APPLICATION NO.	FILING DATE	FIRST NAMED INVENTOR	ATTORNEY DOCKET NO.	CONFIRMATION NO.
09/898,469	07/05/2001	Gang Paul Chen	ChenInterleave	8152
23294	7590	12/08/2003	EXAMINER	
JONES, TULLAR & COOPER, P.C. P.O. BOX 2266 EADS STATION ARLINGTON, VA 22202			JUBA JR, JOHN	
			ART UNIT	PAPER NUMBER

Office Action Summary	Application No.	Applicant(s)	
	09/898,469	CHEN ET AL.	
	Examiner	Art Unit	
	John Juba	2872	<i>HW</i>

DETAILED ACTION

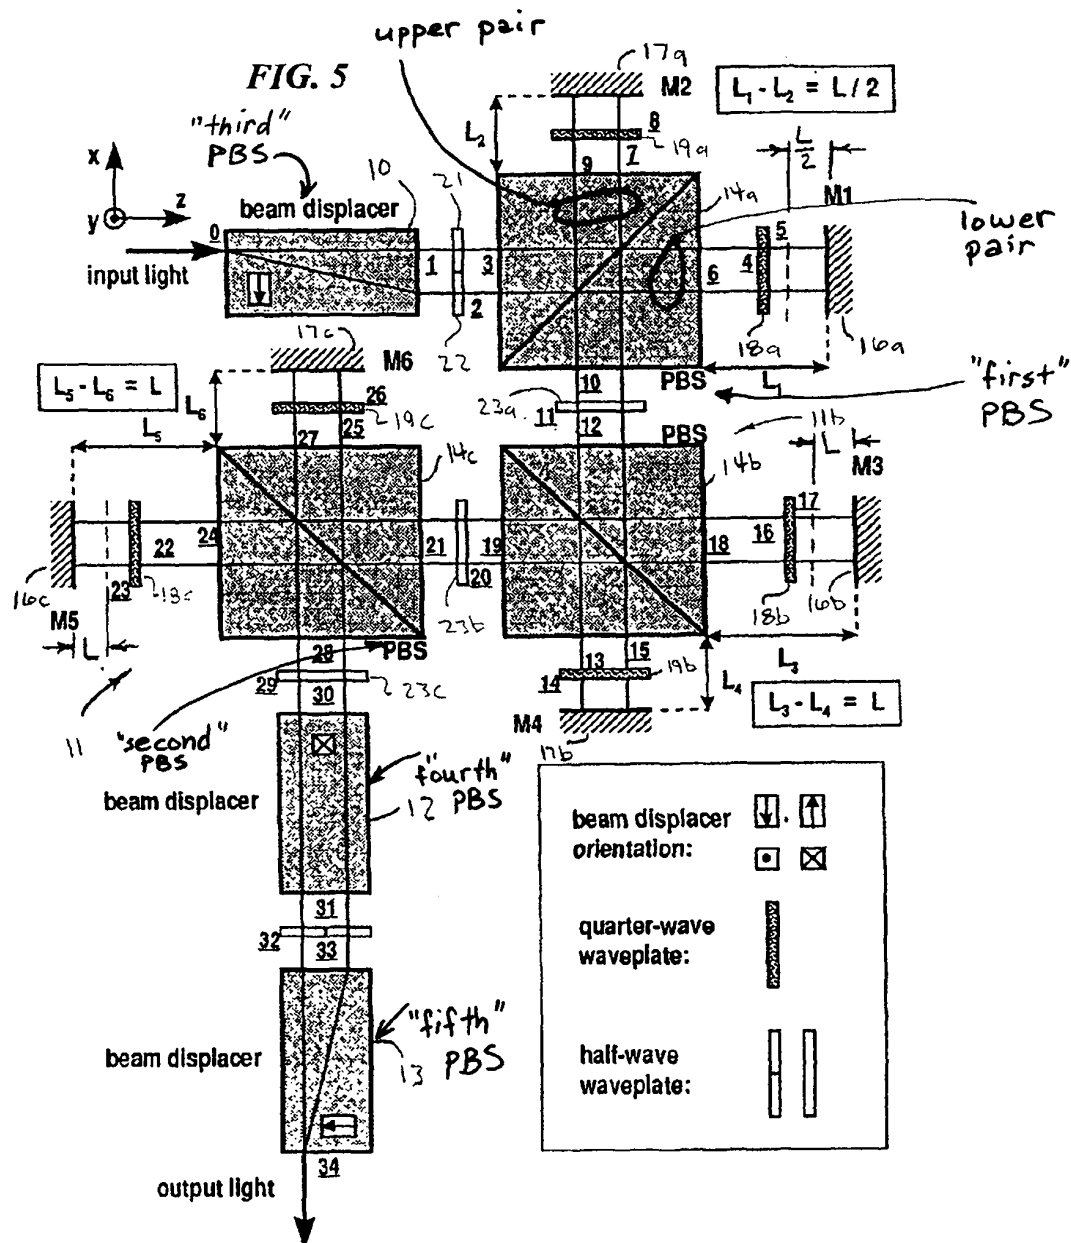
Claims 20, 24, 25, 29, 31, 42, 43, and 46 – 50 are rejected under 35 U.S.C. 102(e) as being anticipated by Zhao (U.S. Patent Application Pub. no. 2002/0048424 A1). Referring *for example* to the discussion of Figures 5 and 6, Zhao discloses first (14a), second (14c), third (10), fourth (12), fifth (13) polarizing beam splitters, the first and third beam splitter cooperating to divide an input beam into upper and lower orthogonally polarized beam pairs, as shown in the attached marked-up copy

of Figure 5. The assembly comprises a number of stages wherein the path length differences are integer multiples (1, 2, and 2) of the same value, L . Waveplates (23a) and (23b) are provided between stages to tailor the response. The characterization of the apparatus as "a microoptic element" is not seen as imparting any positive structural characteristic as would distinguish over the prior art, which has all of the positive recited structure. The provision of athermalized paths is discussed in paragraph [0075].
